USER GROUP

PROXIMITIES & AFFINITIES

CONCERT HALL - Location 1

CONCRETE HALL - LOCATION 2

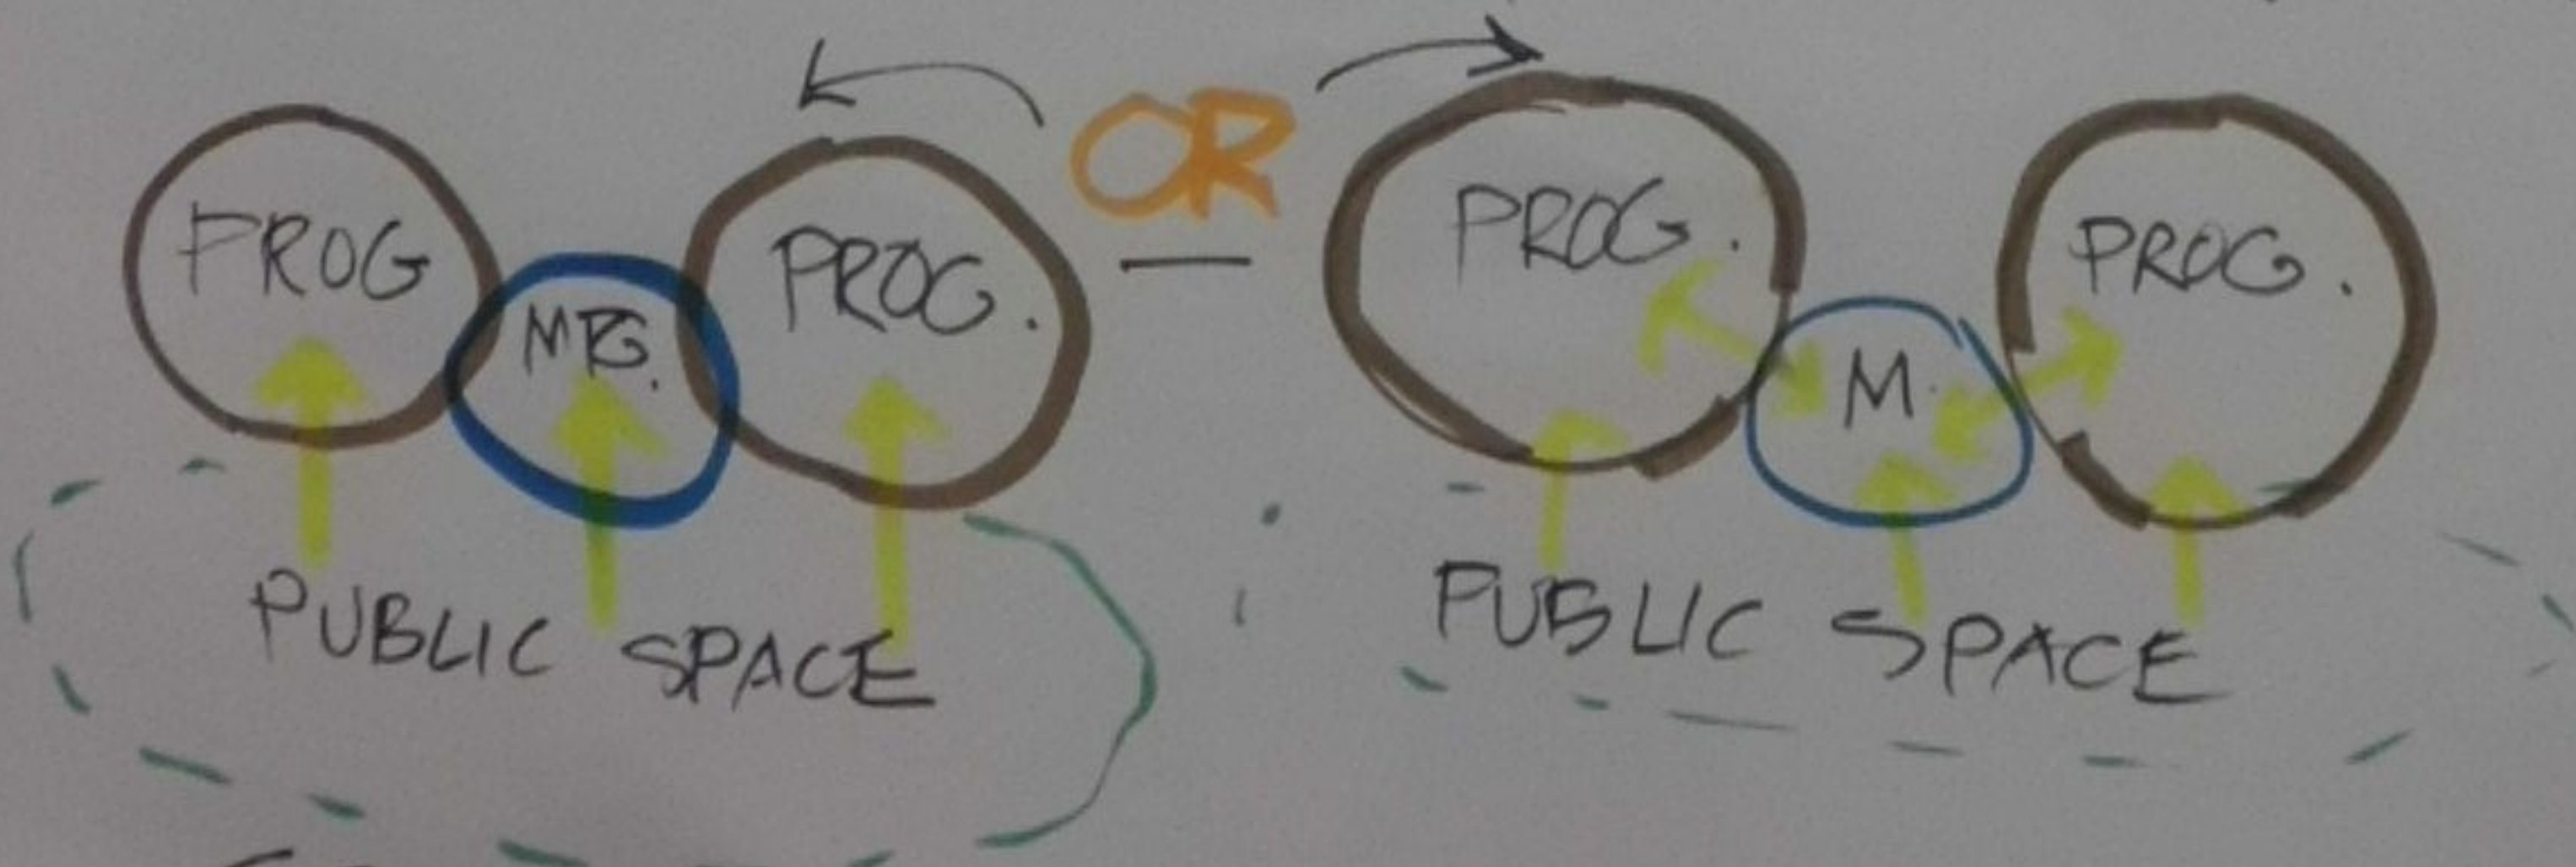
- * ADD "LATE NIGHT" GROUPING OR LAYER
- * ADJUST MCC/HEART RELATIONSHIP?
NOT FISHBOWL VS. NEEDS PRESENCE
- * DOWNPLAY LOCATION IN REAL SPACE
REMOVE "13TH AVE" LABEL
GENERALE STREET RELATIONSHIPS

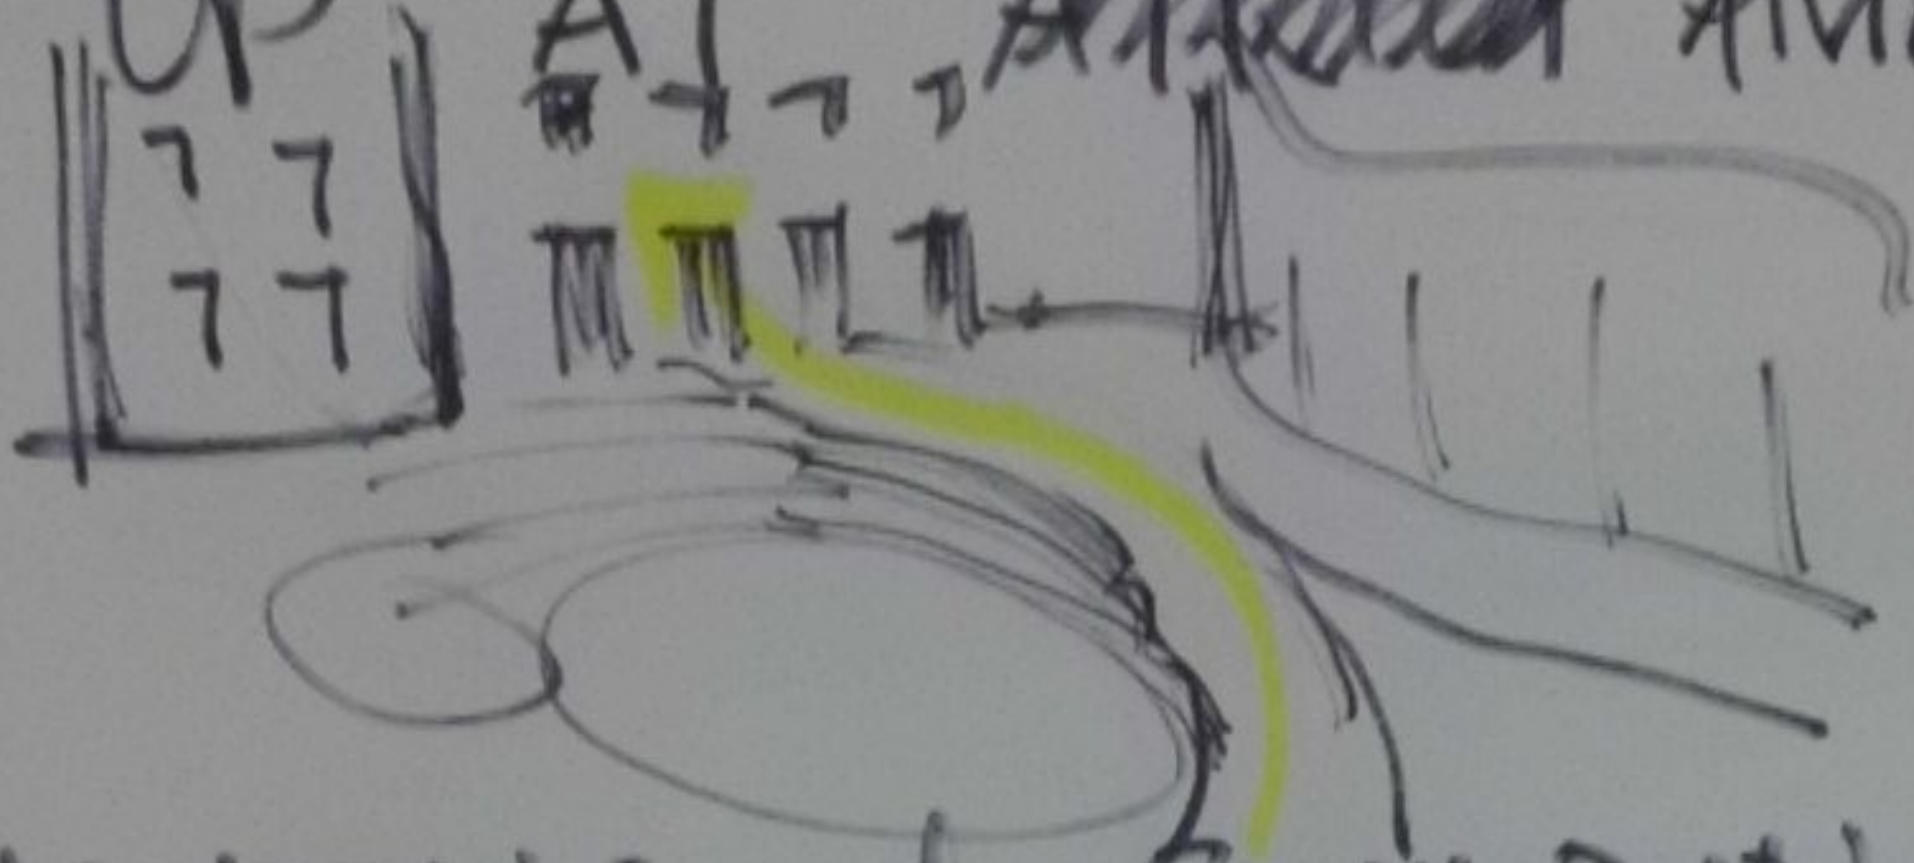
- CONNECTION TO TRANSIT BETTER
- Pro's - LOBBY SHARED
- CONNECTION BETTER TO LARGER STUDENT CENTER

SCALE DROPS
TOWARDS HEART
OF CAMPUS

- CLEARLY DEFINES ACTIVITY ^{UP} "FUNNEL"
- OPTION FOR OUTDOOR MOVIE
- DOESN'T IMPACT LOADING DOCK
- CONNECTION BETTER TO SUPPORT LATE NIGHT ACTIVITY (WITH ATHLETIC NATURAL CENTER)

CONS

- EASIER TO DEPRESS PD TO GRADE.
- LOCATION OF STAGE SHARPER
- OPPORTUNITY FOR OUTER PROGRAM.

CONS

LOBBY SHARED - STUDENTS AFFECTED BY NOISE

- ? WHERE IS THE ENTRY?
- ? WHAT IS ARRIVAL SEQUENCE?
- ? WHERE IS LOADING?
- ? IS MOON TREE SAFE?
